OLD CROSS CUT CANAL

FLOOD CONTROL DISTRICT OF MARICOPA COUNTY

SUBJECT:OCCC PRE-FINAL, SHEET 8.2,8.7

SUBJECT: REVIEW OF OCCC PHASE III 90% PLANS & CALCS

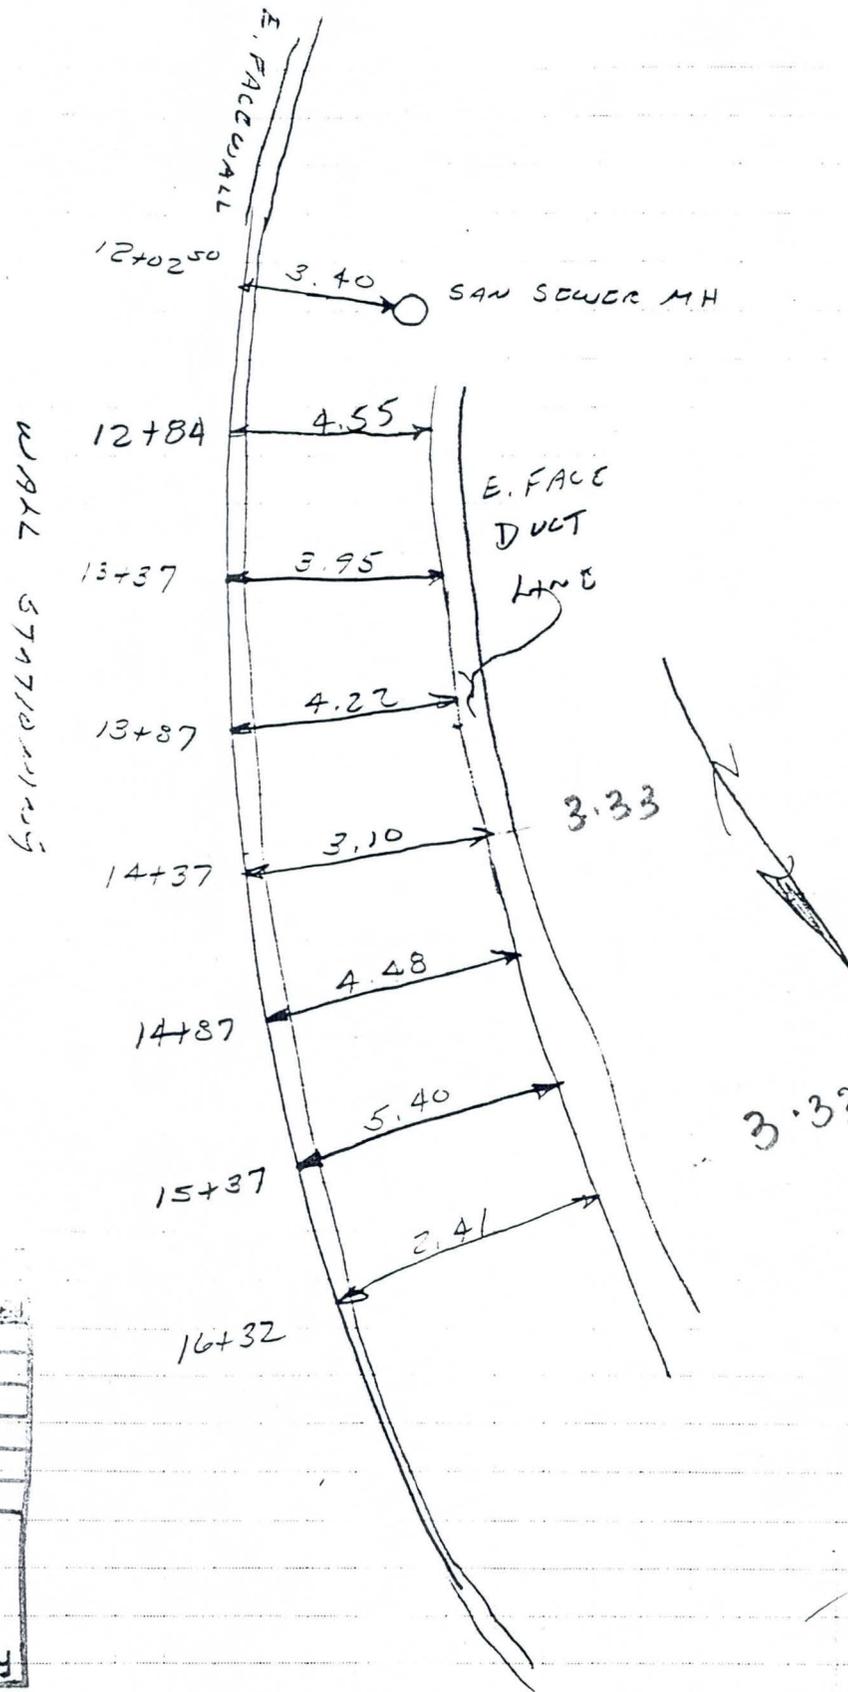
Raj, per our discussion today, please check the HEC-2 runs for the CHIMP assuming the retaining wall at the south end is moved 5' east. Need to determine the impacts on the already approved 100-yr WSE in the CHIMP.

According to our Friday's (12/13) conversation, I have analyzed the effects of moving the west wall 3' east. The Water surface elevation does not change at all because the increase is probably less than 1/100th. But, the encroachment reduces the conveyance area, resulting in increase in velocity as I expected. However, the increase is an average of .02 ft/sec and the highest change is .11 ft/sec so, it is minor and ignorable.

So, in conclusion, the 3' shift of the west wall toward east will not make any significant change in hydraulics.

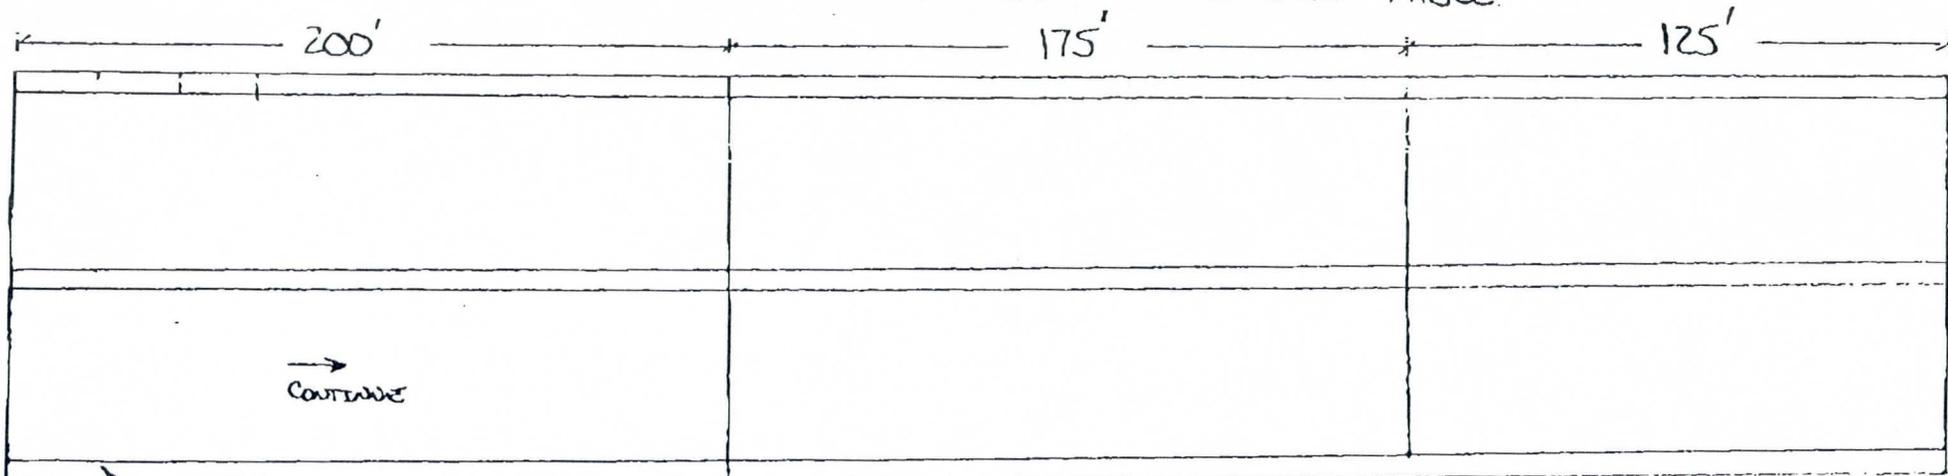
Sundt Corp. requests a clarification on the Joint Note on page C8.1 of the Contract Plans. It requests a construction joint every 36'-6" on the top deck and walls, and every 50' on the bottom slab. Sundt Corp. proposes to place a 1/4" champher strip every 38'-6" to give a weakened plane joint at that location. This has been used successfully on the following ADOT project AC-stp-053-1(29)-H272901C. On the bottom slab, due to the invert being below the water table, we would like to eliminate the joints every 50'.

1. DON'T PLACE THE INVERT IN 3 SECTIONS (200', 175', 125')
2. WITH THE WATER TABLE BEING ABOVE THE INVERT WE DON'T THINK A JOINT EVERY 50' WOULD BE WISE.
3. A 3/4" CHAMFER STRIP WILL BE PLACED ON THE DECK AND AT THE SAME PLACE ON THE WALLS TO GIVE A WEAKENED PLANE TO CRACK THROU.

WEAKENED
PLANE
JOINTS
@ 38'-6" OR LESS
(IN DECK + WALLS ONLY)

ELEVATION (LOOKING INTO 8' X 6' BOX)

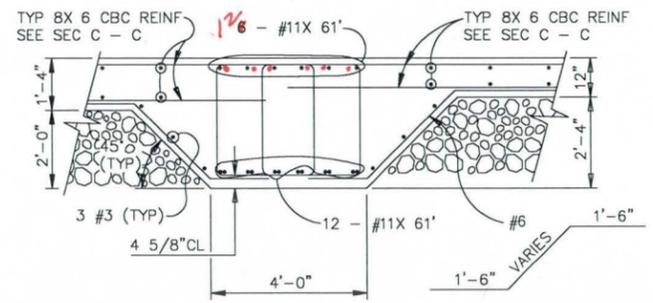
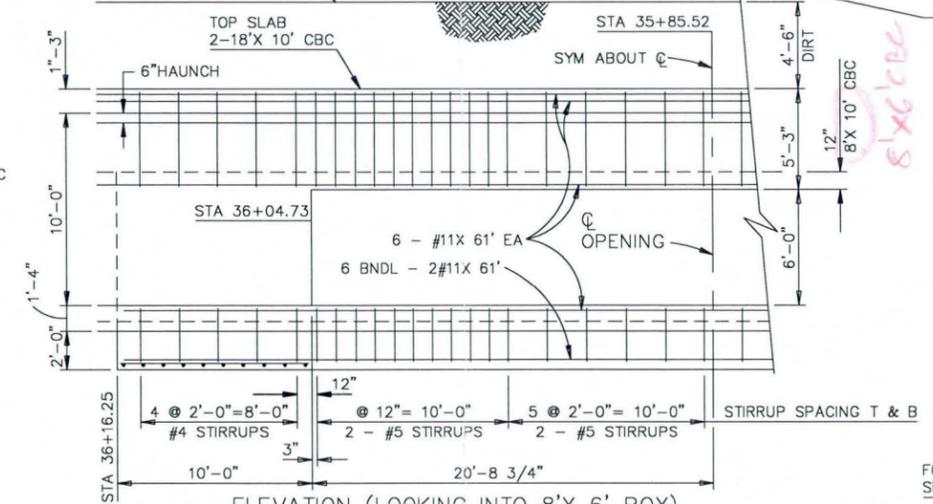
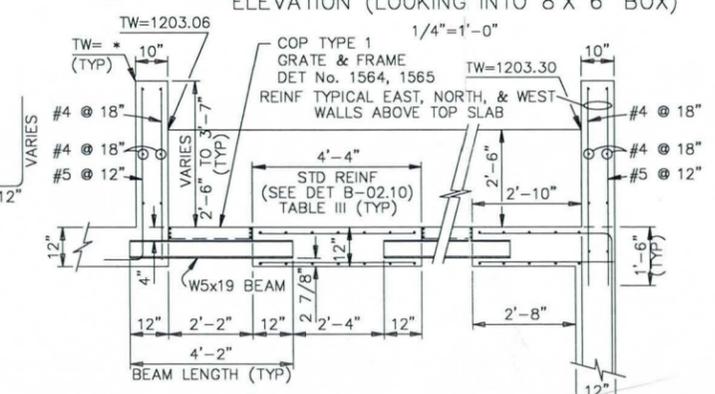
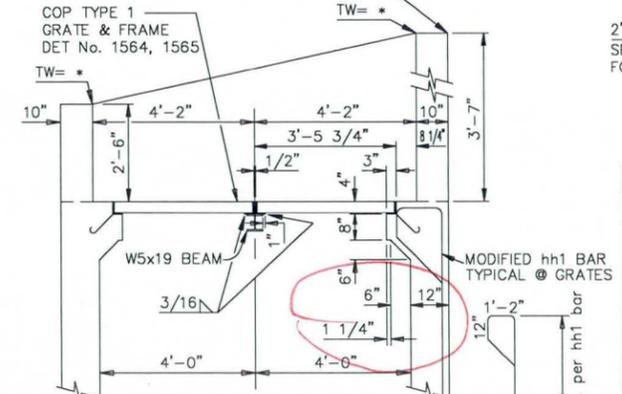
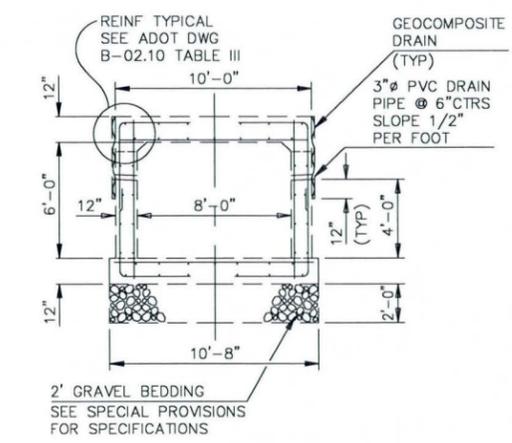
1.PLAN VIEW/ELEVATION(LOOKING INTO 8'X6' BOX)-
THERE SHOULD BE A DETAIL SHOWING HOW THE WALL STEEL FROM THE 18X10 AND THE 8X6 BOXES MERGE TOGETHER AT EACH END.

IT IS UNCLEAR FROM THE PLAN VIEW WHETHER THE INTERSECTING WALLS OF THE BOXES HAVE POINTED OR TRUNCATED ENDS.

THE ELEV VIEW SHOWS THE END OF OPENING AS 36+04.73, WHILE THE PLAN VIEW VAGUELY SHOWS THE TRUNCATED END AS 36+08.85. THE APPARENT BEGINNING OF OPENING STA 35+67.38 PLUS THE LENGTH AT 41.47' = 38+08.85. IF THIS IS CORRECT, THE TRUNCATED END OF THE OPENING AT 38+08.85 SHOULD BE INDICATED CLEARLY ON BOTH VIEWS.

A NOTE ON SECTION C-C CALLS FOR ADOT ST'D REINFORCING, BUT THE DRAWING SHOWS MUCH MORE REINF THAN THE ST'D. THERE IS NO REINFORCING IN THE MIDDLE SLABS TOP OF TOP AND BOTT OF BOTT. THE INLET BOX SHOULD HAVE ADDITION REINFORCING SIMILAR TO THAT SHOWN IN SECT C-C, SINCE THE W5X19 BEAMS WOULD BE EMBEDDED INTO AREAS WITH NO TOP REINFORCING IF THE ST'D ADOT SECTION IS USED.

SECTION @ FOOTING

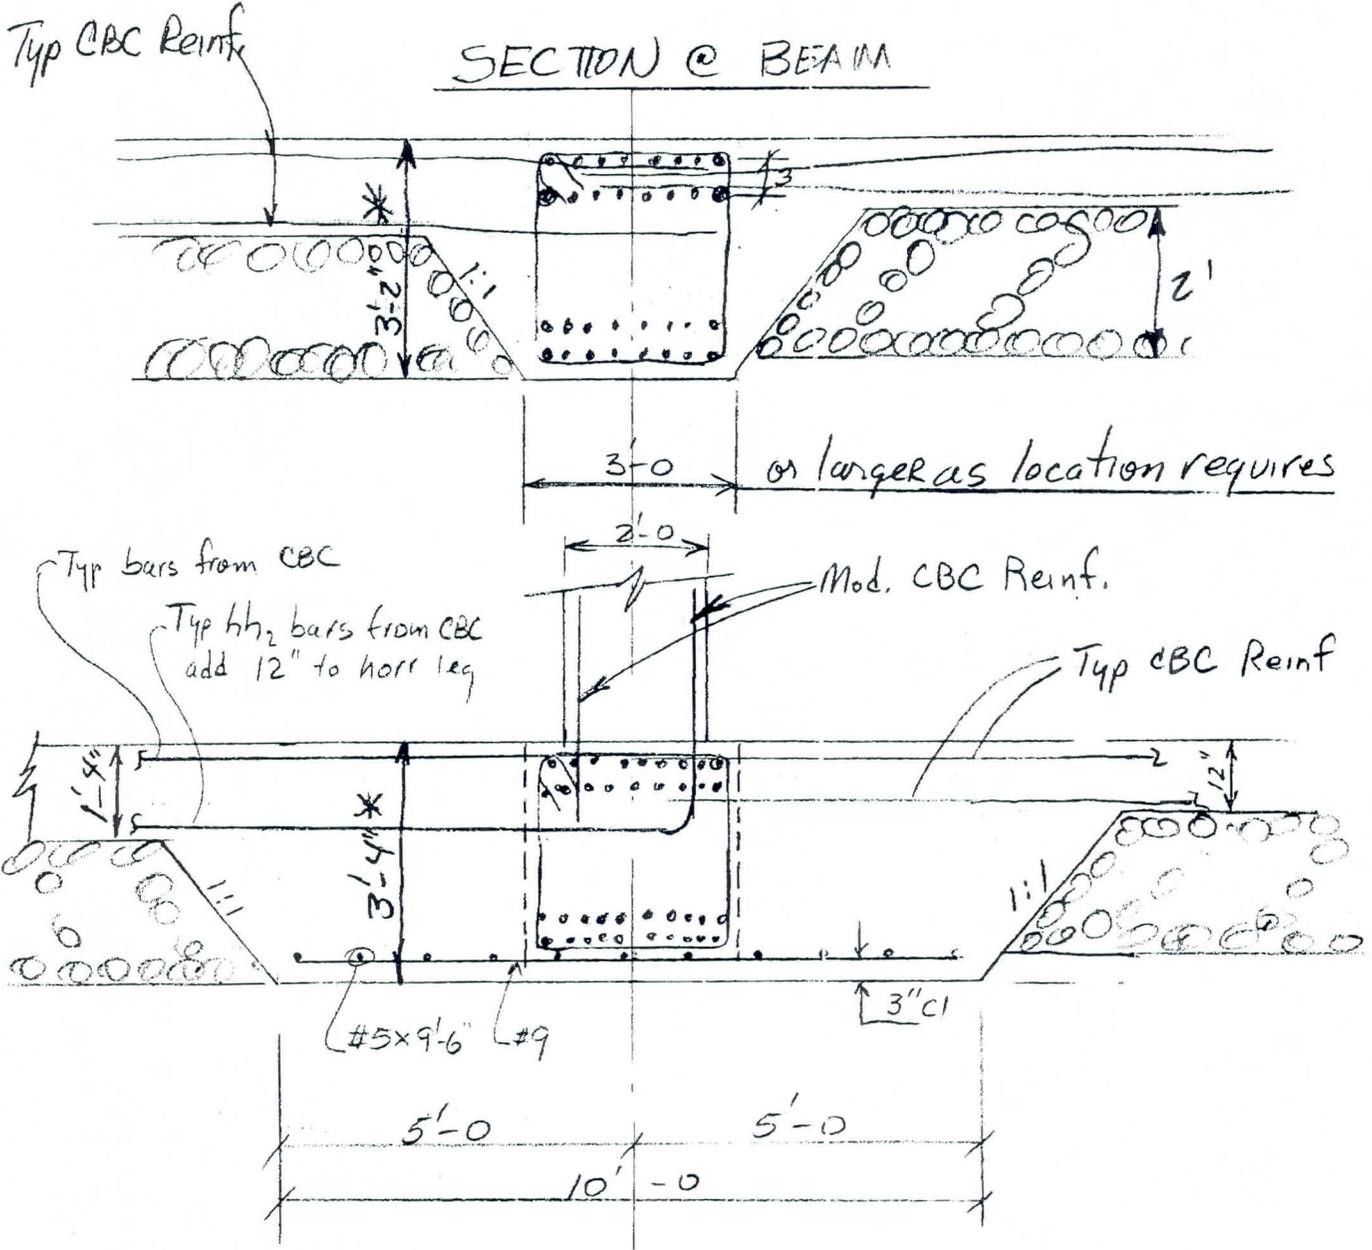
- 1) Deep beam proposed at the foundation level running for the entire length of the opening may not be required, as the loads are transferred directly to the spread footings. All that is required is a thickened slab section where the two bottom slabs meet.
Section D-D, should also show the thickened wall reinforcing transferring load to the spread footings.
Dowels #7 @ 24" shown now may not be sufficient to transfer the load from the wall to the foundations.
- 2) Deep Beam proposed has 12 # 11 bars at the top and 6 # 11 at the bottom. As the full fixity may or may not be developed at the ends, the same 12 # 11 may be used both at the top and bottom to be safe.
- 3) Side inlet at station 75+82 shows a 24" diameter column at the center. Rectangular column with rounded edges is preferable to avoid any punching shear problems at the foundation level.
